HISTORIC PRESERVATION COMMISSION

STAFF REPORT Department of Growth Management

MEETING DATE:	September 7, 2016
PROJECT:	209 Goethe Road – New Construction
APPLICANT:	Randolph Stewart
PROJECT MANAGER:	Erin Schumacher, AICP, Senior Planner

1. **COFA-10-14-8432.** A Certificate of Appropriateness to allow for the construction of a new mixed use building of approximately 3,350 SF and a carriage house of approximately 1,150 SF on the currently undeveloped lot located at 209 Goethe Road in the in the May River Road Development, in the Old Town Bluffton Historic District, and zoned Neighborhood Core-HD.

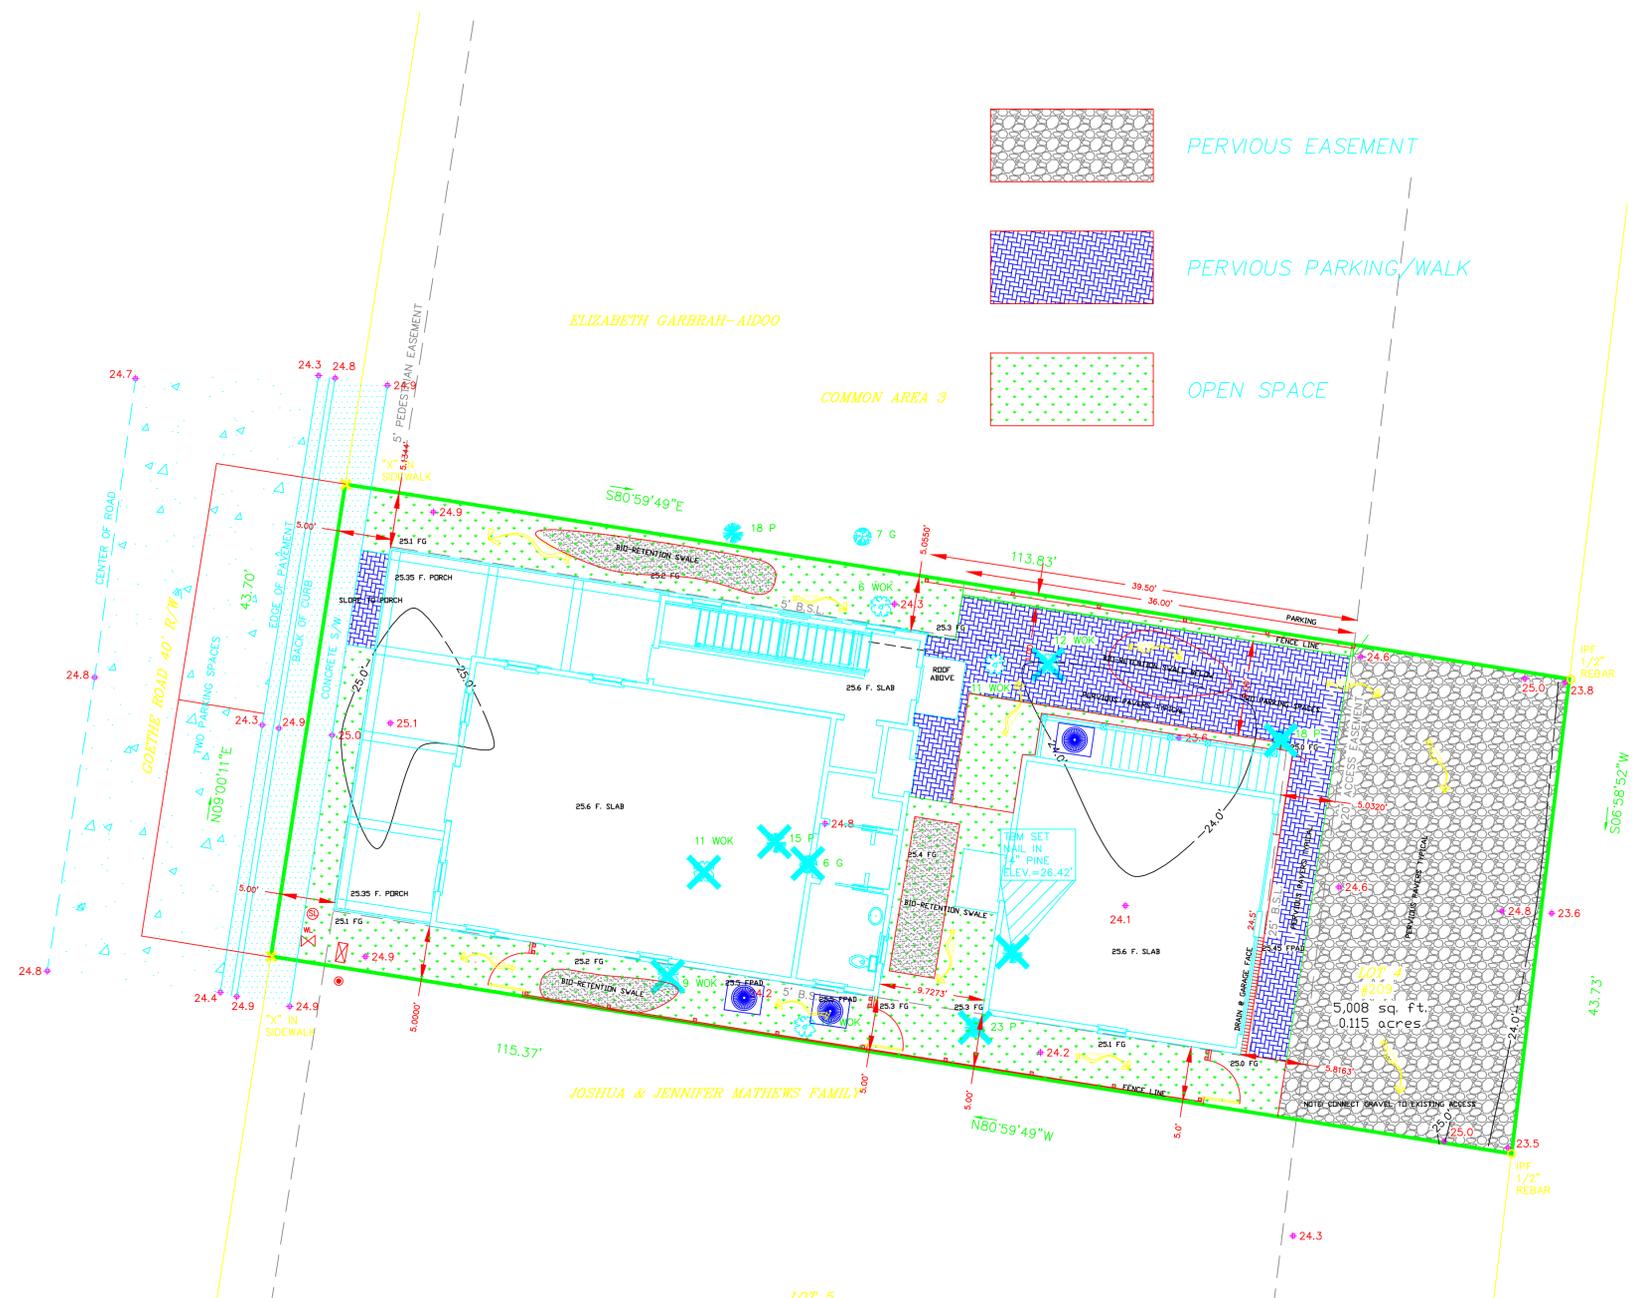
1. It is unclear from the information provided that adequate open space has been planned for on the lot. As the access easement at the rear does not count towards the minimum 20% open space required, an exhibit with the open space calculations is needed for review. (UDO Section 5.6.3.)

2. Regardless of the health or condition of the tree(s), a Tree Removal Permit is required to remove any tree, 8 inches in diameter at breast height (DBH) or greater or any American holly, dogwood, redbud, southern magnolia, or red buckeye 4 inches in DBH or greater. Note that the 18" Pine at the rear of the lot is noted for tree protection in the development plan and that all lots shall have a minimum of 75% tree lot coverage with tree canopy measured as the mature canopy, not including rooftops. (Development Plan and UDO Section 5.3.7.D.1.)

3. For the final application, a landscape plan must be submitted denoting the 75% canopy coverage, street tree locations, and foundation plantings. The landscape plan should take into account the other required plantings noted in the development plan. (Development Plan and UDO Section 5.3.7.)

1 SOUTH ELEVATION
 SCALE: 1/4" = 1'-0"

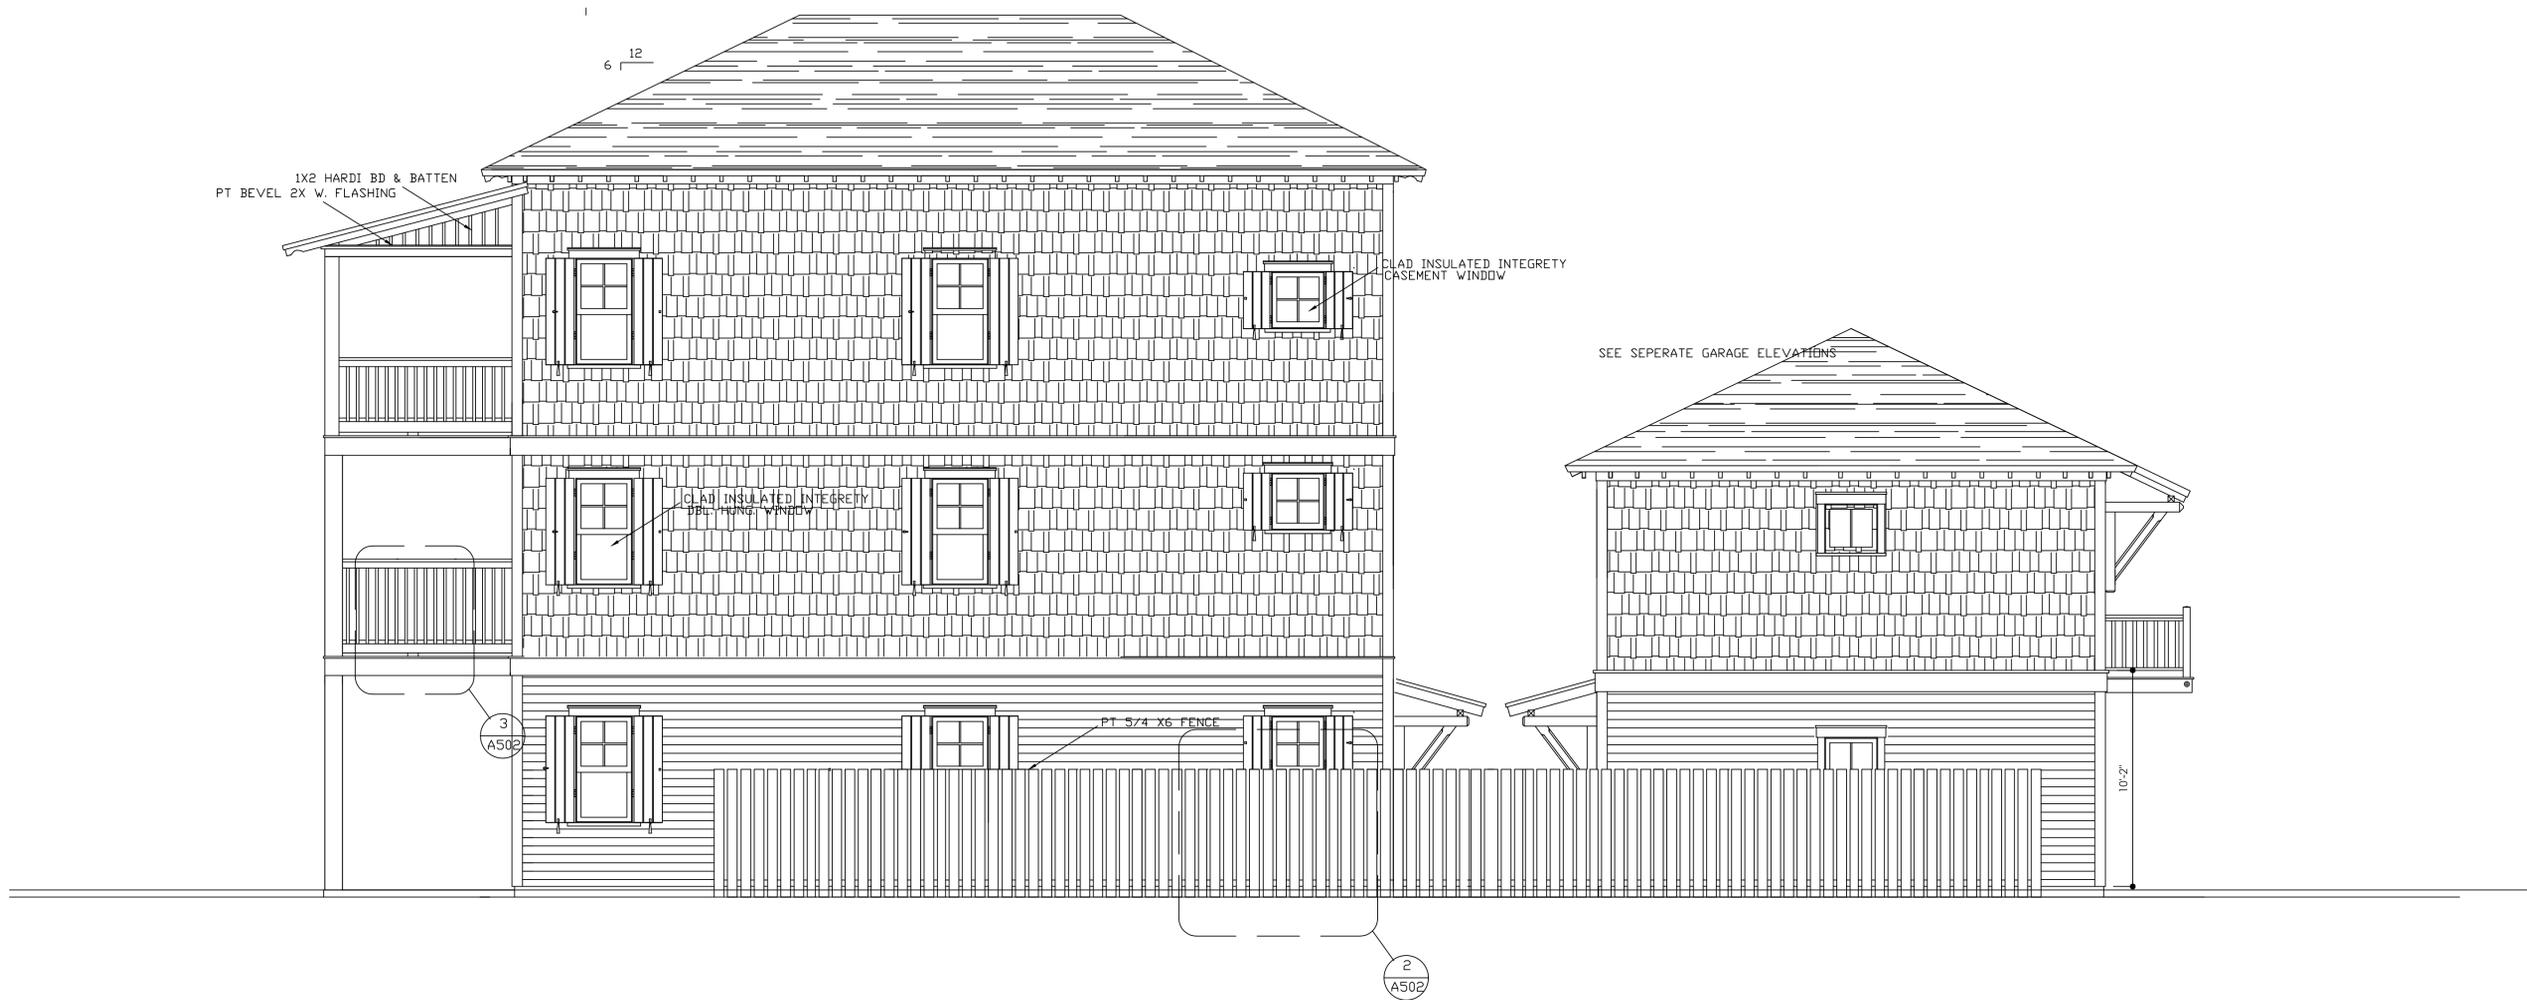
- 2) Section 5.15.8.A. and 5.15.6.L.2. Neighborhood Core Historic District (ND-HD) Opacity and Facades. The UDO requires that Main Street Buildings be shopfront buildings. As such, the UDO states that a shopfront at the first floor shall have untinted transparent shopfront windows and /or doors coving no less than 75% of the wall area. The current proposal has approximately 28% opacity. Additional windows or larger windows/doors must be added to meet this requirement.

3. The second story railing on the south elevation appears to have a drafting error as there is significant space between the balcony decking and the bottom rail. Correct or revise for clarity. (Applications Manual)

1 WEST ELEVATION
SCALE: 1/4" = 1'-0"

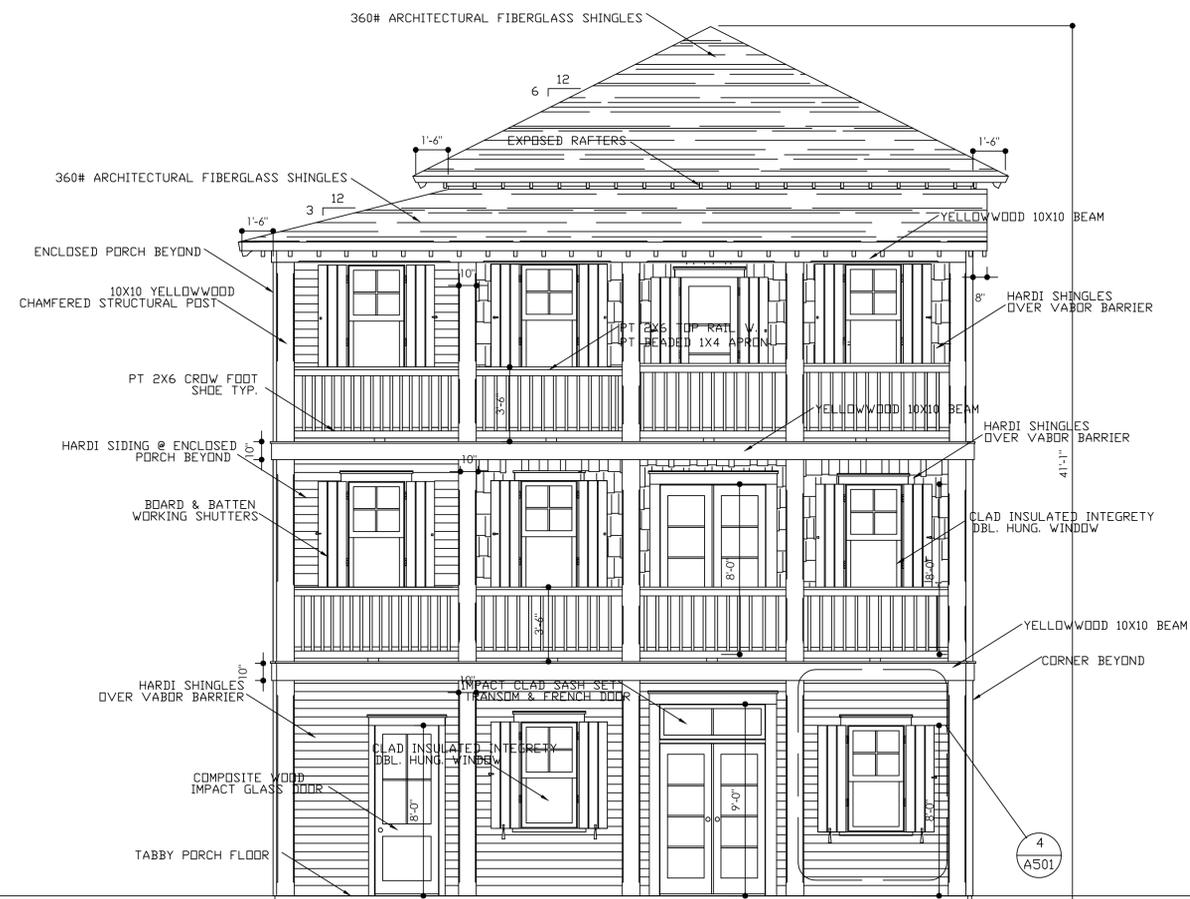
- 1) Section 5.15.5.F.2. General Standards. The UDO notes that rooflines shall be simple, that they shall correspond to the major massing of the building, and that complicated rooflines are to be avoided. As the north and west elevations appear to have a non-traditional termination, they should be revised to a more simplified form.

1. Per Section 5.15.5.F.2. of the UDO, the rooflines of the north and west elevations should be revised to have a more simplified and traditional termination.
2. Per Section 5.15.8.A. and 5.15.6.L.2. of the UDO, additional windows/doors must be added to the first floor shopfront elevation to increase the opacity.

1. Roofs shall correspond to the major massing of the building and complicated rooflines are to be avoided. The north and west elevations appear to have a non-traditional termination. Revise to simplify. (UDO Section 5.15.5.F.2.b.)

2 CARRIAGE HOUSE WEST ELEVATION
SCALE: 1/4" = 1'-0"

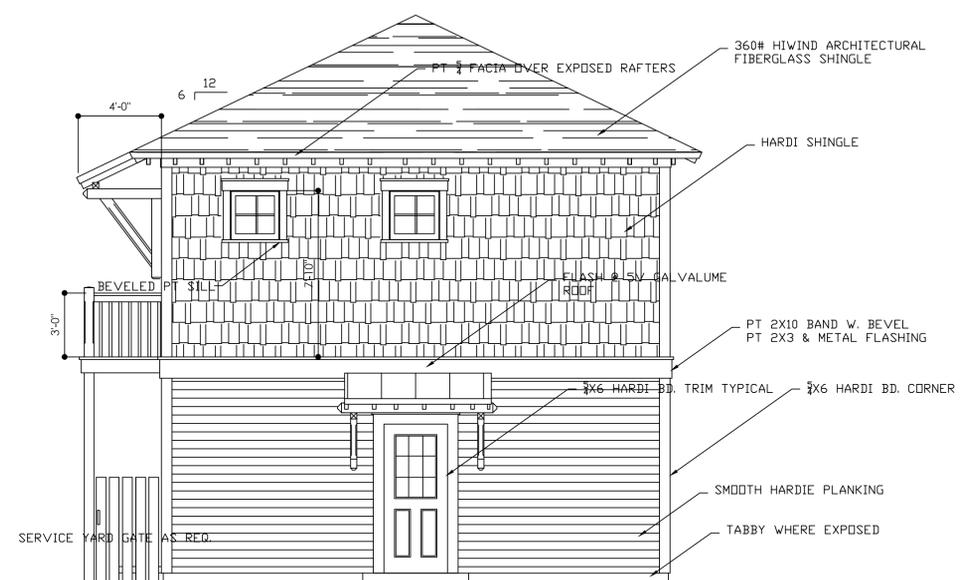
2. For better variety in the wall plane consider using rectangular (tall) windows on the west elevation of the Carriage House instead of the square units that are proposed. (UDO Section 5.15.5.F.3.a.)
